## **REVISION DESCRIPTION:**

### **Kit Assembly Instructions:**

**FIGURE 1: WING INSTALLATION (LEFT SHOWN)**

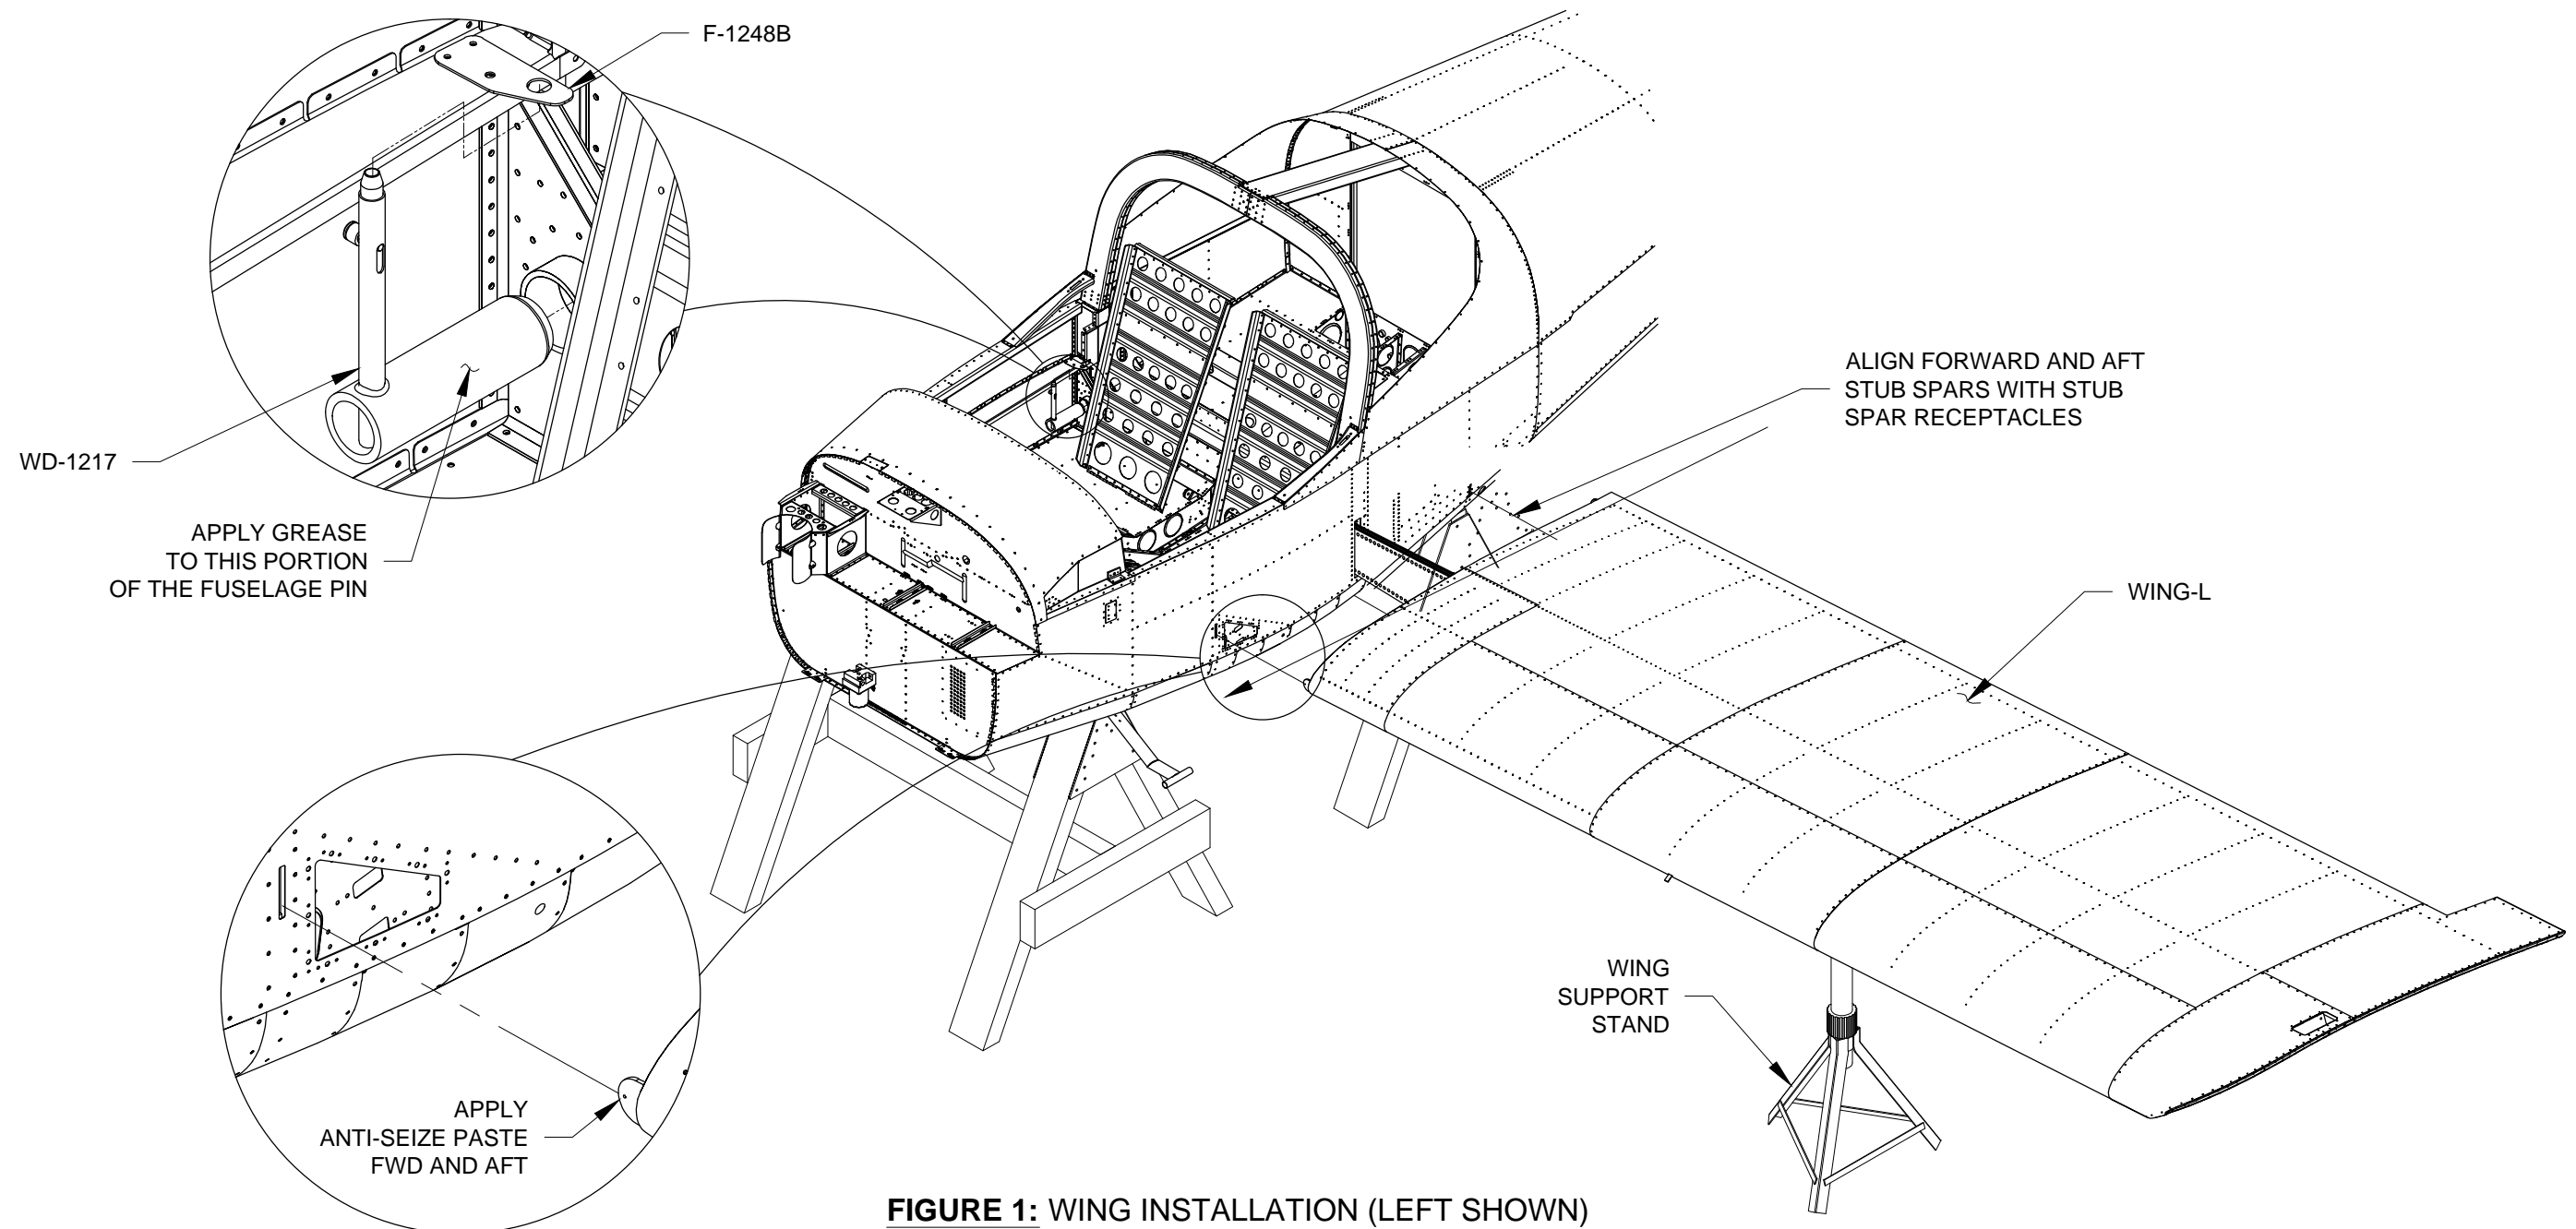
**30-03 REV 2** added "Step 5: Check the gap between the flaperons and fuselage skin. A minimum gap of 1/8 inch is required to allow smooth flap deployment. Use sharp metal snips or a file to remove material from the inboard edges of the Flaperon skins to achieve the 1/8 inch gap."

**Step 5:** Check the gap between the flaperons and fuselage skin. A minimum gap of 1/8 inch is required to allow smooth flap deployment. Use sharp metal snips or a file to remove material from the inboard edges of the Flaperon skins to achieve the 1/8 inch gap at full up deflection.
